CUSTOMER: P/N: **0287.180** REV. . APPROVED BY:

QUAIL ELECTRONICS, INC.®
http://www.quail.com

UNIT: mm SHEET: 1 OF 1 REV. **J**

DWG NO: 0096-2058

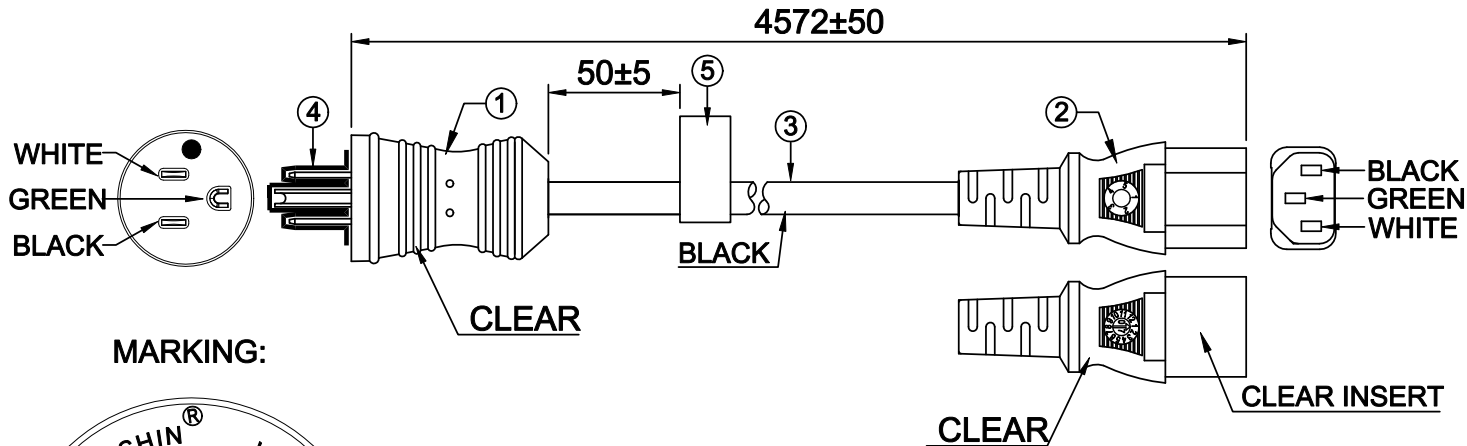
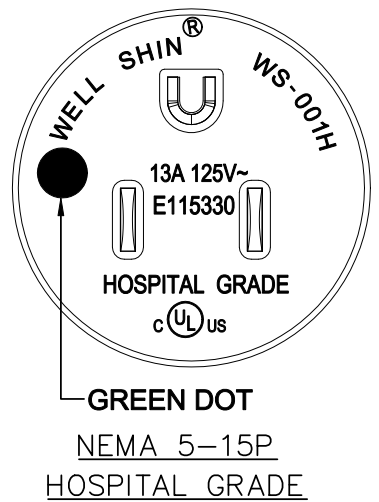
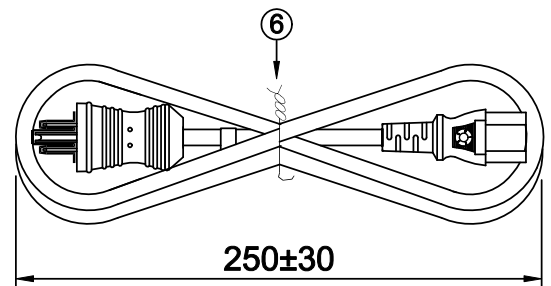
REVISIONS		
REV.	DESCRIPTION	DATE
△	The plug insert changed to the exposed type Change the cable specification and note 1.4	2024/11/05

- △ 1. ZH(Zhang Hwa) factory begin from revision C.
- 2. RoHS shown on the carton
- 3. WS-002 Use a Clear Insert
- △ 4. The shield must be connected ONLY to the green cable(earth) on both plug/connector
